Access Compliance Report

Public Rights-of-Way

Intersection ID: N/A	Main Street: COMMUNITY_HOUSE_RD	Cross Street: N/A	Location: NW
ADA ID: 13EA3AB17B61	Ramp Type: Perp	Initial Pass/Fail: Fail	Overall Compliance: No
		Severity Score: 12.5

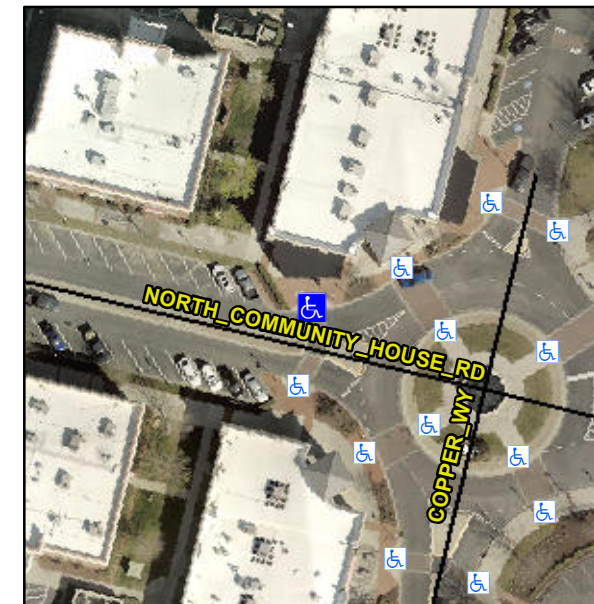
Not Found, R304.2.2

Compliance	Description	Data	Compliance	Description	Data
N/A	Ramp Length (in)	74.0	No	Ramp Slope (%)	8.6
Yes	Ramp Width (in)	120.0	Yes	Ramp XSlope (%)	1.0
N/A	Flare Type LT	N/A	N/A	Flare Type RT	N/A
N/A	Flare Slope LT (%)	N/A	N/A	Flare Slope RT (%)	N/A
N/A	Flare Traversable LT?	N/A	N/A	Flare Traversable RT?	N/A
N/A	Landing Length (in)	N/A	N/A	DWS Provided?	N/A
N/A	Landing Width (in)	N/A	N/A	DWS Contrast?	N/A
N/A	Landing Slope (%)	N/A	N/A	DWS Length (in)	N/A
N/A	Landing X Slope (%)	N/A	N/A	DWS Full Width?	N/A
N/A	Landing Curb? (Y/N)	N/A	N/A	DWS Offset (in)	N/A
N/A	Shared Landing?	N/A			
N/A	Gutter Ponding?	N/A	N/A	Gutter Slope (%)	N/A
N/A	Gutter Lip Ht (in)	N/A	N/A	Gutter X Slope (%)	N/A
N/A	Painted X Walk1?	Yes	N/A	Painted X Walk2?	N/A
	X Walk 1 Direction	To S		X Walk 2 Direction	N/A
N/A	X Walk 1 Width (in)	104.0	N/A	X Walk 2 Width (in)	N/A
	X Walk 1 Slope (%)	0.2		X Walk 2 Slope (%)	N/A
	X Walk 1 X Slope (%)	1.1		X Walk 2 X Slope (%)	N/A

Remove & Replace Entire Ramp.
